3-I-21-HZ
APPLICATION FOR CERTIFICATE OF APPROPRIATENESS

1111 Eleanor St. 37917
 Fourth and Gill H

Staff Report

File Number: 3-I-21-HZ

site plan

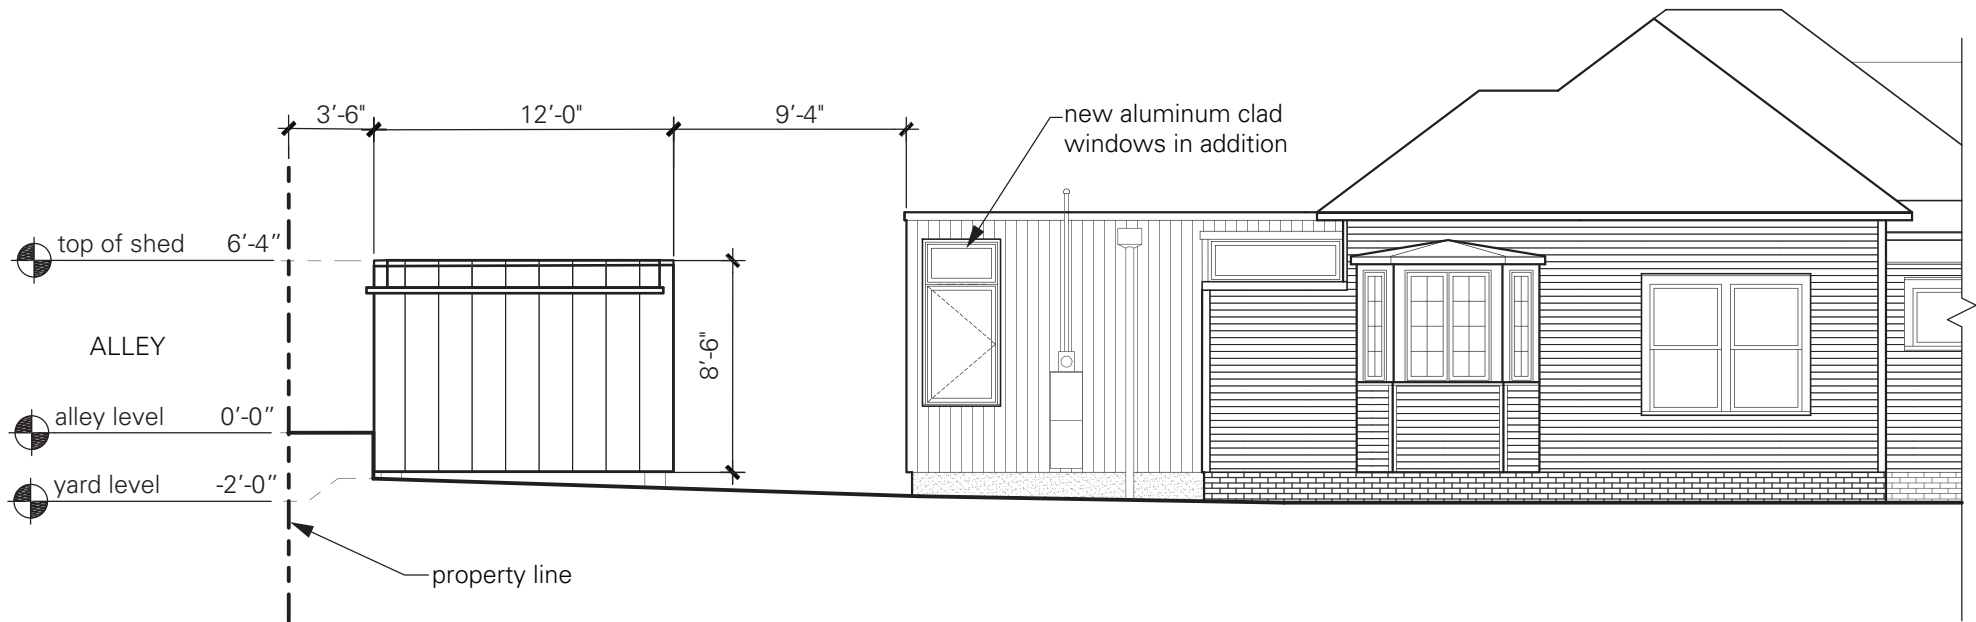
3. The proposed outbuilding will be recessed behind the primary residence and an existing wood fence. The shed is proposed to be set 1'-4" from the interior (left side) property line and 3'-6" from the rear property line; base zoning requires a minimum of 5' from property lines. The proposal is scheduled for review by the Board of Zoning Appeals on 3/16/21. If the necessary variances for setbacks and building coverage are denied, a revised site plan will need to be submitted.

8. The application does include a new curb cut, which guidelines note "should be kept to a minimum," especially when the addition of curb cuts "results in removing historic sidewalks, curbs, or retaining walls." The proposed parking would continue an existing pattern; there are at least five existing curb cuts off the 1100 "block" of the west side of Eleanor Street. There is an operable alley behind the house, though topographic and lot constraints may not make rear yard parking possible. The installation of a new curb cut would not require the removal of historic sidewalk, curb, or retaining wall materials. The proposed two strips of permeable pavers will not have a detrimental effect on the house or the block's historic context.

Staff recommends approval of the work with the following conditions: 1) submit final dimensions of porch columns and balustrade for approval by staff; 2) incorporation of additional elements connecting the shed with the original house, with approval by staff; and 3) if the applicant does not receive the necessary variances at the 3/16/21 BZA meeting, a revised site plan showing placement and dimensions of the shed should be submitted.

front elevation (east)

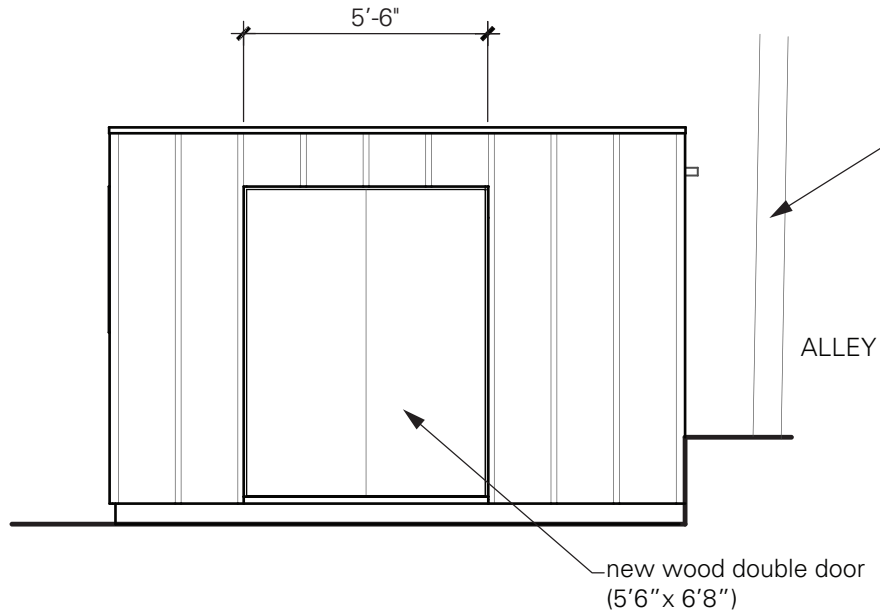
5. Removal of the non-historic wrought iron columns and railing meets the design guidelines. The proposed turned wood columns and square wood pickets are compatible with the historic house and similar designs in design and material. Final specifications should be submitted to staff with dimensions of turned wood columns and balustrade. The turned wood columns should reflect the originals in size and scale (visible in paint ghosts on the porch beam). Balusters should be set into the top and bottom rails of the guardrail.

6. The new attic vent is based on documentation of the original detail and meets the design guidelines. The Commission should discuss the installation of cedar shingles in the front gable field without documentation of the originals; however, the currently-visible asphalt shingles may have been installed to replace original wood shingles. The new cedar shingles are proposed for a small section of the front gable field, are not overly elaborate or detailed, and similar in size and placement to comparable houses in the district.
